Hellwig Rear Stabilizer Bar End Link

Bulletin Type:	TSB	Publication Date:	May 2025
Bulletin #(s):	25-002	Make(s):	Jayco, Entegra
Job Code(s):	9803623	Model(s):	Condor, Granite Ridge
Flat Rate(s):	9803623 0.3 HR Hellwig Stabilizer Bar End Link Repair	Model Year(s):	2024-2025

FIELD FIX INSTRUCTIONS REAR STABILIZER BAR END LINK

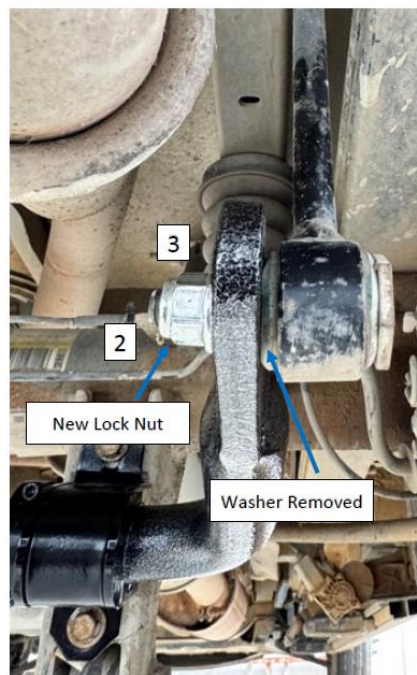
Incident:	Hellwig rear stabilizer bar end link lock nut is loose.
Affected Units:	2024-2025 Jayco Granite Ridge; 2024-2025 Entegra Condor
Parts Kit:25-002JM	Parts Kit #: 25-002JM
	2 - Locknuts
Misc. Tools & Supplies:	Torque wrench, socket wrench, adjustable wrench
Parts Return Information:	N/A

- 1) BEFORE STARTING YOUR INSTALLATION, BE SURE TO SET PARKING BRAKE AND CHOCK TIRES.
 - 2) TO EASE INSTALLATION AND TO PROPERLY ADJUST THE BAR, THE WEIGHT OF THE VEHICLE MUST BE ON THE SUSPENSION, AS IF DRIVING DOWN THE ROAD. DO NOT RAISE VEHICLE BY THE FRAME
1. Remove the Locking Nut (#2) and washer from the lower end of the end link attached to the rear sway bar. Discard the washer and lock nut on the vehicle.
 2. Open the Hellwig resupply lock nut kit. Install the new lock nut onto the end link and tighten down each side to the factory end link rod.
 3. Use a torque wrench to torque down the locking nuts to 90ft lbs.
